United States Patent and Trademark Office

APPLICATION NO.	FILING DATE	FIRST NAMED INVENTOR	ATTORNEY DOCKET NO.	CONFIRMATION NO.
10/720,593	11/24/2003	Albert A. Simone	SPADIX 3.0-003(DIV)	5032
	7590 02/08/2007	EXAMINER		
EZRA SUTTO) PLAZA 9	N, FA	FLETCHER III, WILLIAM P		
900 ROUTE 9 WOODBRIDGE, NJ 07095			ART UNIT	PAPER NUMBER
			1762	
SHORTENED STATUTOR	Y PERIOD OF RESPONSE	MAIL DATE	DELIVERY MODE	
3 MONTHS		02/08/2007	PAPER

DETAILED ACTION

FIG.1

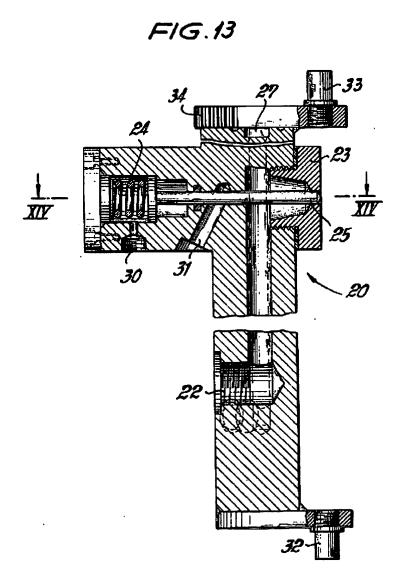
- (b) the invention was patented or described in a printed publication in this or a foreign country or in public use or on sale in this country, more than one year prior to the date of application for patent in the United States.
- 10. Claims 36-38 and 41 are rejected under 35 U.S.C. 102(b) as being anticipated by Jarchow et al. (US 3,947,311 A).
- A. This reference teaches a process for forming an insulated glass assembly by extruding sealant into the space defined by two glass panes and a spacer element. While not explicitly stated, it is the Examiner's position that the resultant space is U-shaped (circled below):

Hot-melt sealant material is extruded from nozzles having a structure illustrated in Figs. 13 and 14:

Material enters the nozzle structure via opening 22, flows through recessed space running vertically up (anticipating **claim 41**) to nozzle outlet channel contained in 23, where it is held until valve 25 is opened and the material exits the nozzle outlet opening. The nozzles are moved along all sides of the insulated glass assembly as illustrated in Figs. 7-12.
